Supplement Sheet

Subject: 21" Single Stage Auger Assemblies Comparison

Models Affected: 21" Single Stage Model Series 140, 150, 160, 170, 285 and 295

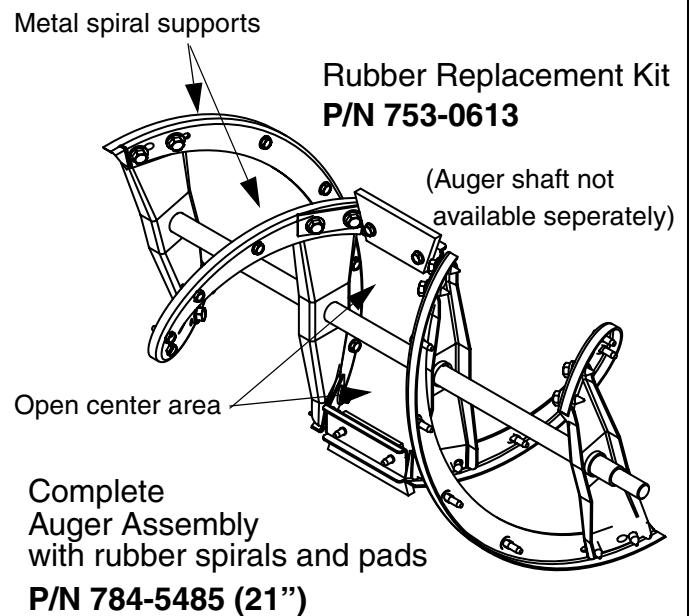
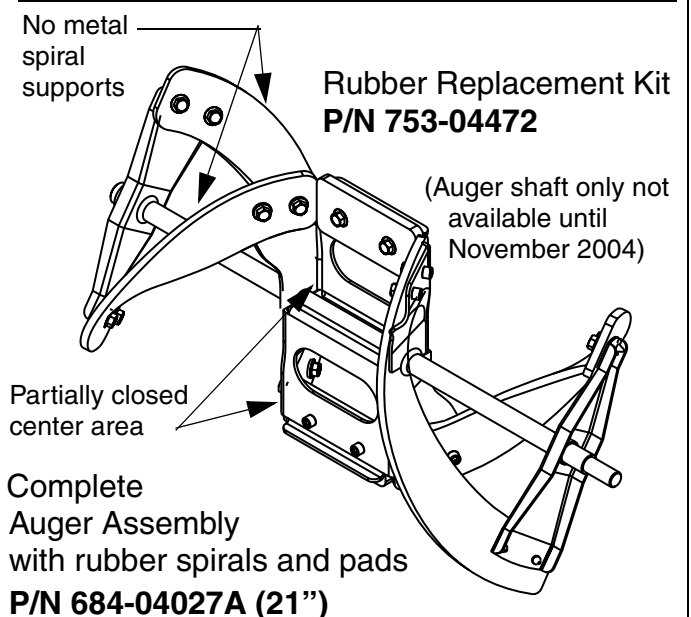
Due to supply issues your snow thrower may have a different Auger Assembly than depicted in your Operator's Manual illustrated parts list.

When replacement of the rubber spirals and pads is required you will need to verify which auger assembly is on your snow thrower. The illustration shows which replacement kit is required for that auger configuration.

The Auger Assembly **784-5485** is depicted in the top illustration on the right. This configuration has metal spiral supports that the narrow rubber spirals mount to. The center paddle area is open.

The Auger Assembly **684-04027A** is depicted in the bottom illustration on the right. This configuration has heavy duty rubber spirals that mount to the metal end spokes. There are no metal spiral supports for the curved rubber spirals. The center paddle area is partially closed by the combination paddle support and spoke brackets.

NOTE: *After November 2004 the complete auger assembly 684-04027A will not be available. The auger shaft, without rubber spirals and pads, will be available as part number 684-04025A. After November 2004, to obtain a complete auger assembly you will need to order the auger shaft, 684-04025A and the rubber replacement kit 753-04472 separately.*
